Product Update: Insight ECM

Product Update: 2000 Insight

Engine Control Module:
P/N 06380-PHM-A00, H/C 6441117

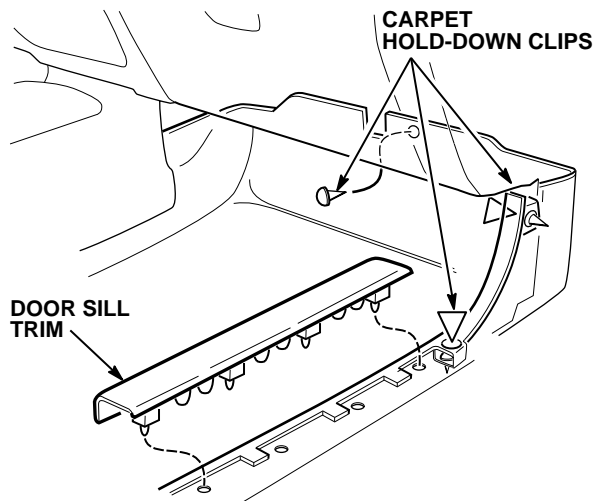
The engine may not start if the ambient temperature is below 0°F (-20°C).

Replace the ECM (engine control module) with an improved unit. After the ECM replacement, the immobilizer system must be reinitialized. Make sure you have all the customer's keys.

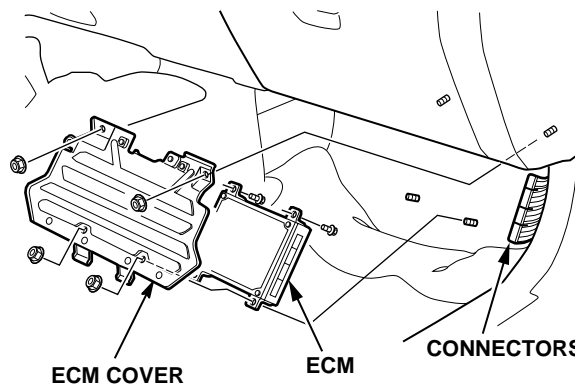
4. Remove the ECM cover mounting nuts.

5. Pivot the lower edge of the ECM cover off the mounting studs. Lift the upper edge of the cover off the mounting studs, then pull the cover down and back so it clears the evaporator drain tube.

6. Remove the two bolts mounting the ECM to the cover. Disconnect the ECM connectors.

7. Install the new ECM in the reverse order of removal.
